## 15A Plant Nuclear Safety Operational Analysis (NSOA)

The information in this appendix of the reference ABWR DCD, including all subsections, tables, and figures, is incorporated by reference with the following departures.

Figure 15A-7 Safety System Auxiliaries—Group 2

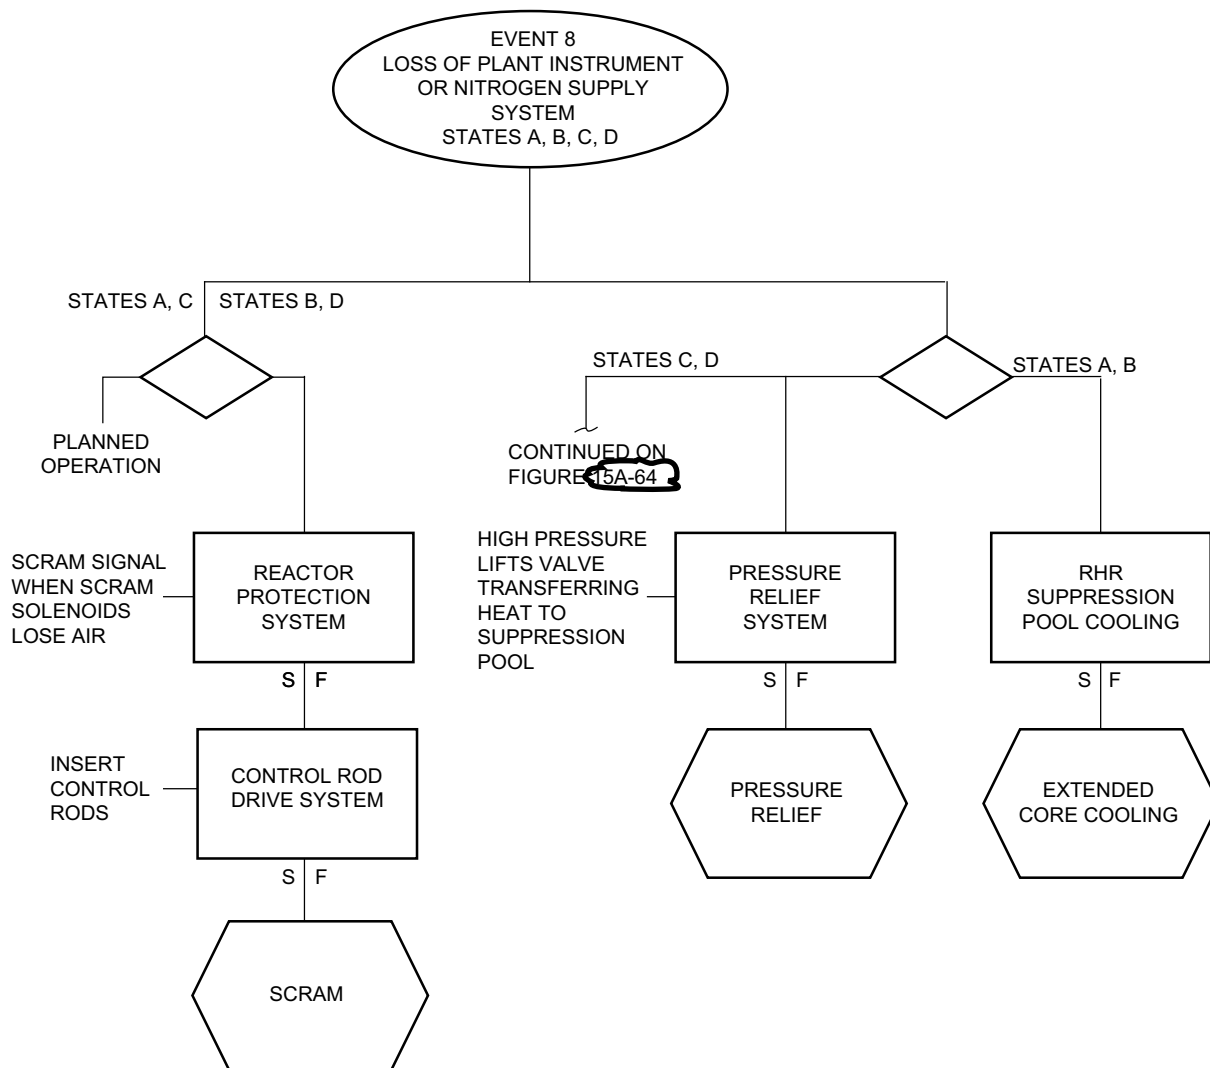
STD DEP T1 2.14-1 (Figure 15A-7)
